## **OBJECTION TO MP 06 \_0309 MOD 3**

Trinity Point Drive Morisset Park. Johnson Property Group

Irene Bates  
58 Pillapai Road  
Brightwaters  
NSW 2264

Figure 1

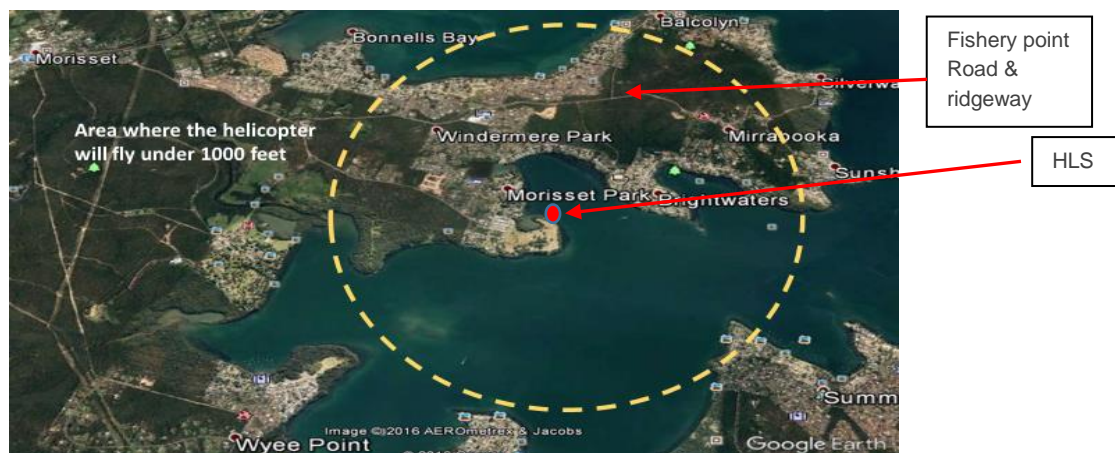
The following figure (yellow dotted line) indicates where helicopter operations will be under 1000 feet.

Given that JPG indicates that council officers were consulted regarding the locations for noise measurement and with knowledge that the helicopters overfly included the ridgeway, noise measurement equipment should have been placed according to Item 3.7 (page 5) of the AS2363-1999

The measurement locations listed in JPG's acoustic report does not take into considerations the overfly, take-off and landings when proceeding over the ridgeway along Fishery Point Road and above Morisset Peninsula – including Morisset to Balcolyn, Silverwater and Sunshine. All of which are located within 2 klms of the proposed helipad site.

It is identified that JPG's Appendix E did not conduct noise testing requirements according to **Item 3.7 (page 5) of the AS2363-1999 – Acoustic – Measurement of noise from helicopter operations.**

Based on this information it is recommended that JPG's Appendix E is considered as invalid.

Figure 2 Landing flight paths

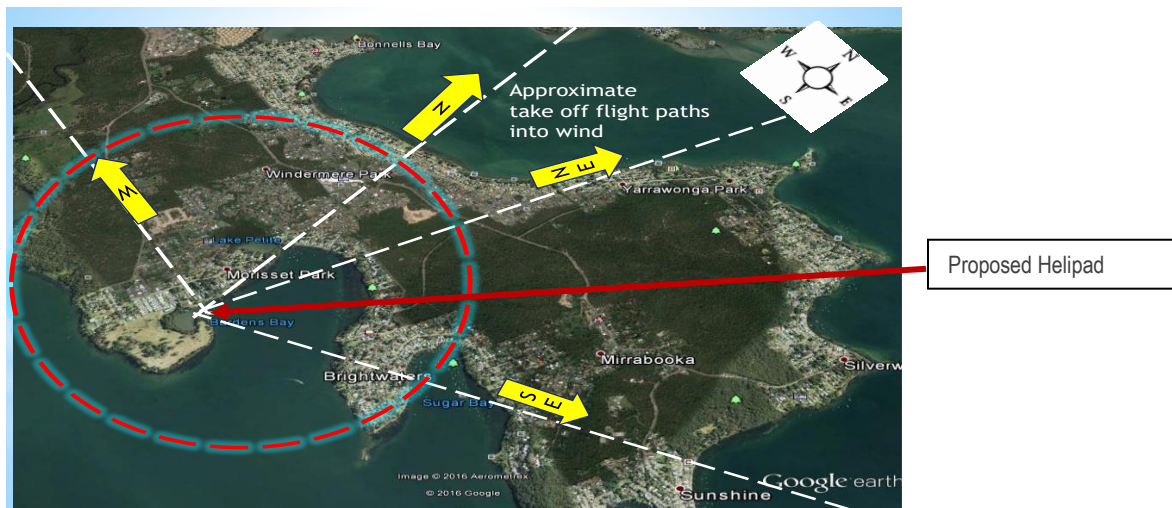
1. Over 7000 homes will be affected by helicopter/ aviation noise.
2. Helicopters and/ or seaplanes will descend from 1000 feet within the outer circle.
3. Helicopters and/ or seaplanes will be below 500 feet within the inner circle.
4. The pilot will take the most appropriate path and '*land into wind*' (as indicated in JPG's Appendix D - A5 & A6).
5. The reality is that the '**preferred flights**' listed in JPG's are inaccurate and do not consider the prevailing winds in Bardens Bay.
6. JPG's documents do not represent or identify a true compass reading for the prevailing winds in relation to their statement Appendix E –A5 & A6

In Figure 2 (below) pilots of helicopters or seaplanes will descend below 500 feet over houses before landing at the proposed site. All pilots of helicopters or seaplanes will land 'into wind' and this means that up to 4 hours each day (8 movements each day) a resident is exposed to the noise from helicopters and/ or a seaplane.

This means that although there are 'preferred flight paths' the pilot will over-ride these flight paths in favour of landing and taking off into wind.

Therefore, the flight paths identified by JPG are misleading and there is no guarantee that these proposed flight paths will ever occur.

- a) The proposed flightpaths contained in JPG's appendix E; A3, A4, A5 & A6 are misleading
- b) The proposed flightpaths do not take into consideration '*that the pilot will choose their own flight paths*' & *Pilots will normally always land and take-off into the prevailing wind.*'
- c) The proposed flight paths do not accurately identify the prevailing winds for the area.
- d) There is no 'compass' to identify the wind direction.
- e) Reconnaissance and overflight is required as a matter of safety.
- f) The Fly Friendly Neighborhood is identified as a 'preferred flight pattern.' Pilots will make their own decision according to wind direction.

The information contained in JPG's appendix E; A3, A4, A5 & A6 are misleading and inaccurate. It is therefore deemed that Appendix D is invalid.
